**RE: City of Seguin
Rudeloff Rd Project
Change Order #1**

Contract Change Order No.1
Rudeloff Road PH I

OWNER: City of Seguin
CONTRACTOR: Texas Sterling Construction
CONTRACT AMT: \$15,394,288.00
Project : Rudeloff Road PH I

ESTIMATE AND QUANTITIES

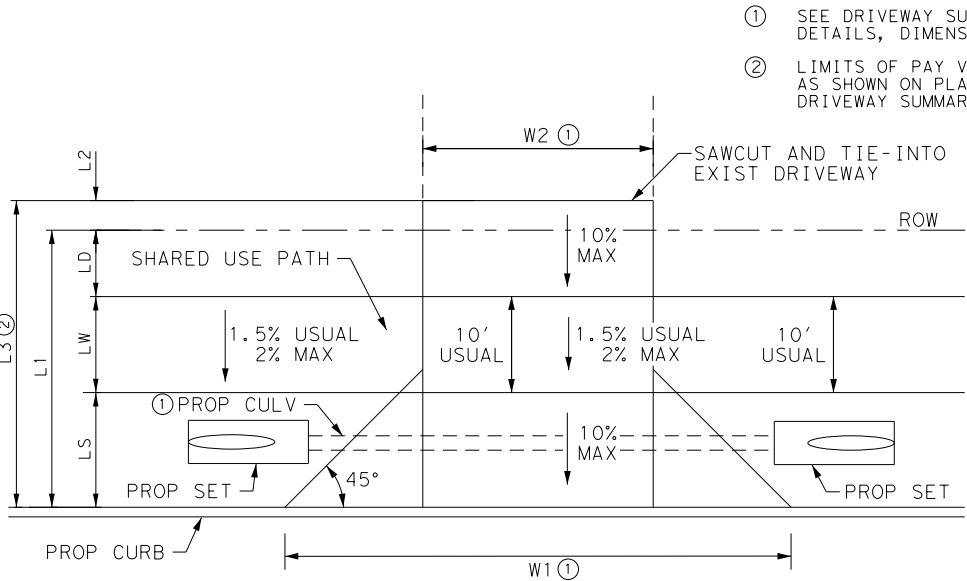
1. This addition to the contract is for the Spring Hills Water Supply line adjustment.
2. This portion of the change is for the removal of a portion of the Berridge parking lot that is within the project right-of-way. The removal is required to install proposed bid items.
